Board limitations

Board identification

This errata sheet applies to certain STMicroelectronics X-NUCLEO-53L7A1 expansion boards, which are marked on the front with the FG X\$NUCLEO-53L7A1A, as indicated below.

Figure 2. Oval cover glass included in the identified expansion boards blister

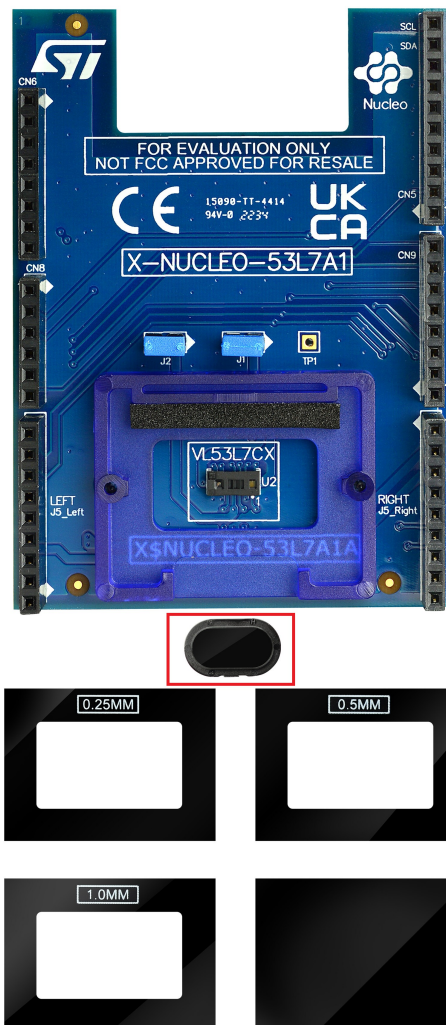
- Part number affected
 - Boards identified by the FG X\$NUCLEO-53L7A1A
- Description
 - The oval cover glass included in the blister is not designed for the on board Time of Flight sensor.
- Workaround
 - Do not use the included oval cover glass.
